*LUCAS COUNTY  
PLAN COMMISSION  
REPORT*

*October 28, 2015*

2. S-22-15: Preliminary drawing for Crystal Ridge Plats 2-6, located east of Strayer Road, north of Monclova Road (bh)

PRELIMINARY DRAWING  
OF  
**Crystal Ridge  
Plats 2 thru 6**  
A PLANNED UNIT DEVELOPMENT  
MONCLOVA TOWNSHIP, LUCAS COUNTY, OHIO

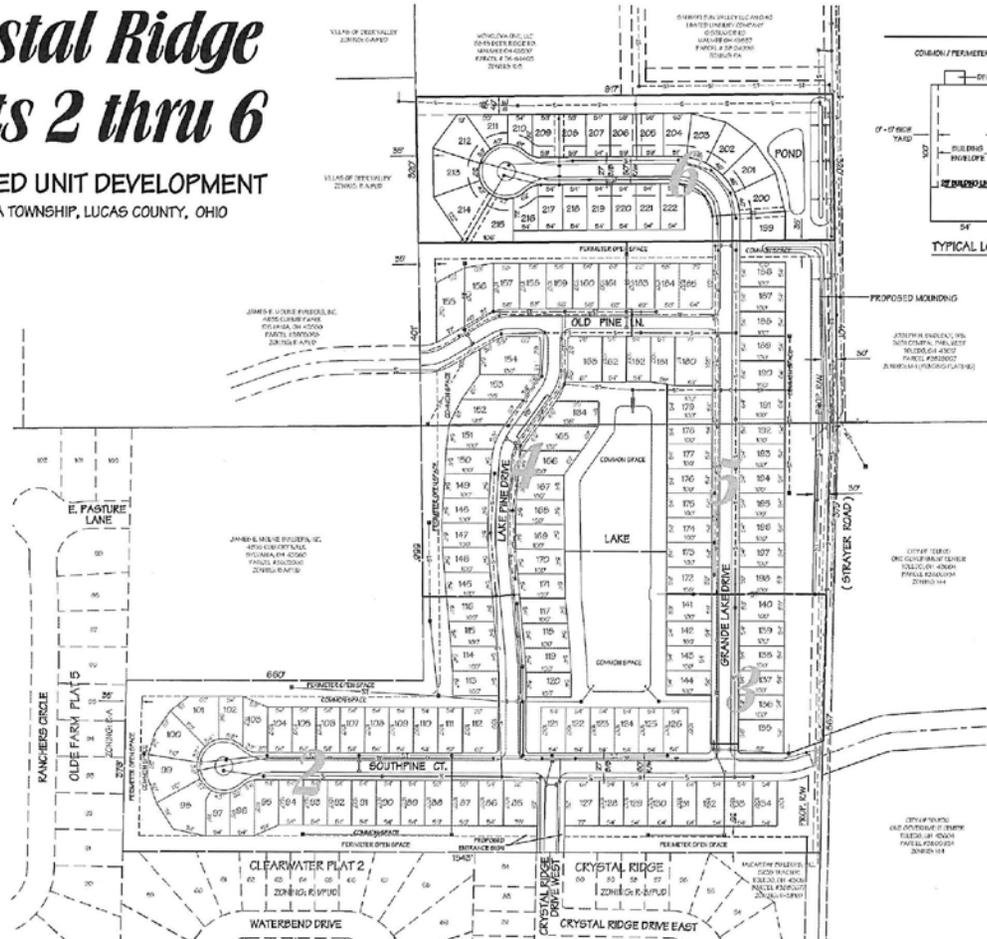
Pursuant to the Monclova Township Zoning Resolution, PUDs require no minimum lot size, lot-width, building or structure setbacks. However, staff noticed that Lot 210 appeared to have a significantly reduced building envelope due to its location on the cul-de-sac. The applicants engineer has indicated that a minor change in the plan will off-set the cul-de-sac to the south therefore creating an additional building envelope size for lot 210.

The Lucas County Subdivision Rules and Regulations, *Sec. 507.f*, requires that any subdivisions with adjacent undeveloped land create stub streets to connect future development. The site has undeveloped land to the north. A waiver of the stub street to the north is not supported by staff as the potential exists for the development of this land into the future. The roadway extension to the north would require the reconfiguration of the proposed subdivision lots.

When a residential area of a Planned Unit Development abuts an Industrially Zoned District, an open space perimeter area shall be provided that has a minimum depth of seventy-five (75) feet. This open space shall be void of buildings, structures, parking areas, or other above-ground improvements except fencing shall be maintained along all perimeter property lines of the Planned Unit Development. The previously approved plat and planned unit development allowed for the construction of mounding along the entire eastern property line. The applicant was indicated that the mounding appeared to only extend midway down Plat 5, the applicant stated that this was in error and the mounding was intended to extend the entire length of the western property line.

10. Road name is not identified on the drawing. Road name subject to review and approval of the fire department to avoid similar sounding road names in the area.

15. There should be more information identifying plat six in particular i.e. acreage, number of lots etc.
16. The perimeter open space for plat six should be labeled.

29. The preliminary plat drawing for Eclat Commerce & Business Center includes a future extension and widening of Strayer Rd. beginning at the intersection of Jerome Rd. and Technology Drive and extending westerly and then curving to the north to connect at Maumee-Western Rd. (US 20A). An additional fifty (50) foot right of way and twenty-five (25) foot highway & utility easement shall be dedicated in accordance with the proposed future street alignment at the northeast corner of Plat 6 to accommodate this future roadway extension and widening.

30. A street name shall be provided for the cul-de-sac in Plat 6.
31. The developer shall be responsible for the actual plan review and construction inspection time performed by the County Engineer's Office associated with the pavement and drainage

35. Per Lucas County Subdivision Rules and Regulations **Sec. 507.f**, a stub street shall be required for the undeveloped land to the north unless a wetland delineation identifies the presence of wetlands that would prohibit development to the north.

Subdivisions are required to provide stub connections along any perimeter where undeveloped land is present. An undeveloped, fifteen (15) acre parcel exists to the north of the site and is conducive to future development. Staff recommends that the Lucas County Planning Commission **DENY** of a waiver of the stub street requirement.

The staff further recommends that the Lucas County Planning Commission approve S-20-15, a Preliminary Drawing for CRYSTAL RIDGE PLAT 6, located east of Strayer Road & north of Monclova Road, subject to the following **thirty-six (36)** conditions:
